BOSTON EDISON COMPANY
800 BOYLSTON STREET
BOSTON, MASSACHUSETTS 02199

Proposed Change No. 5

License No. DPR-35
Docket No. 50-293

Proposed Administrative Technical Specification Change

PILGRIM 1 STATION ORGANIZATION
 FIGURE 6.2.2

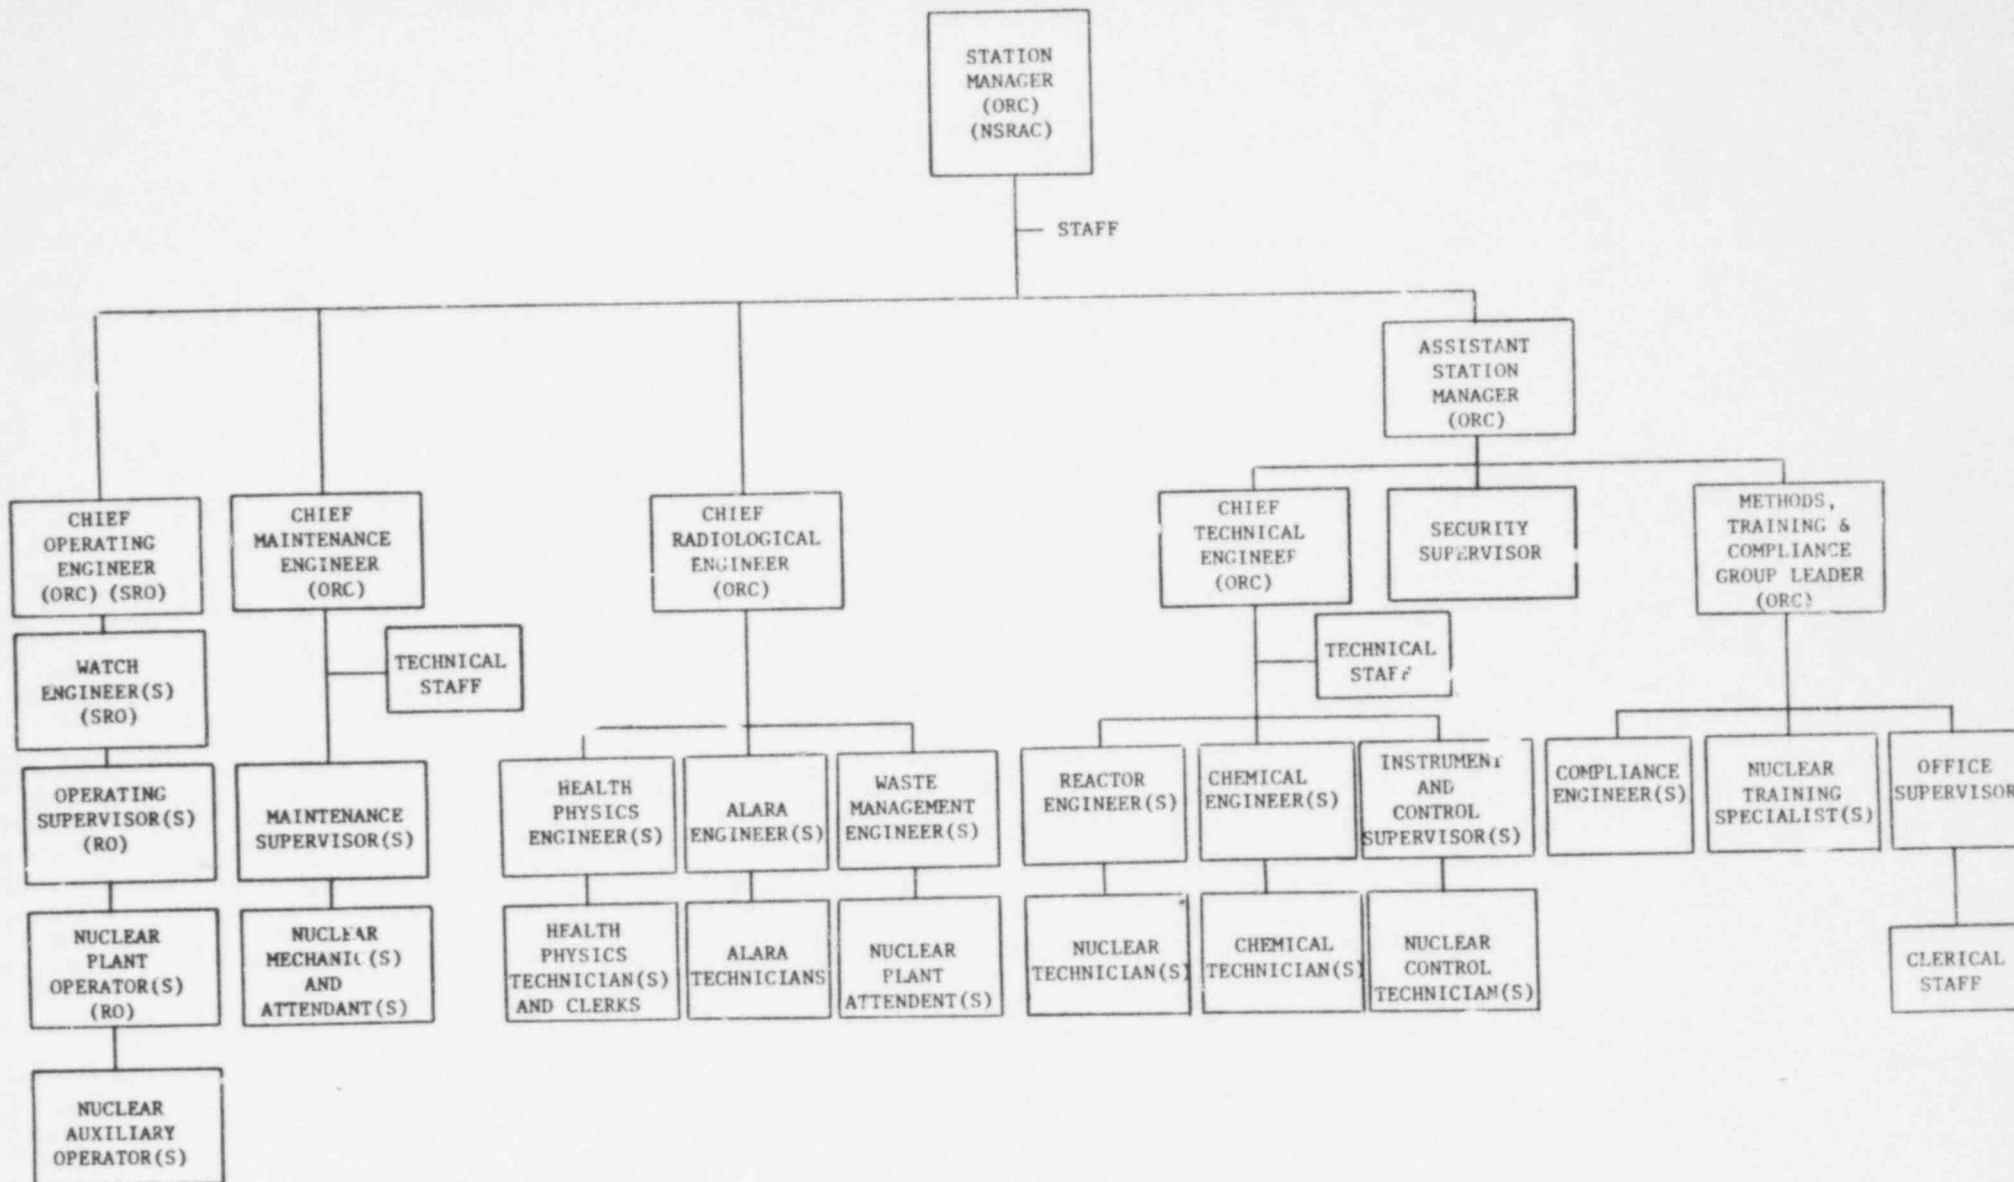
Reference is made to Pilgrim Nuclear Power Station - Unit #1 Technical Specification Appendix A, Section 6, Figure 6.2.2, titled "Pilgrim #1 Station Organization". The changes would consist of restructuring the chart (Exhibit A) to accommodate organizational changes at the Station. Also, Section 6.5.A.2 "ORC Composition" will be updated to reflect the position titled "Vice Chairman".

This new position in conjunction with the re-structuring of reporting requirements as shown in Exhibit A, will serve to improve workload distribution through the Station.
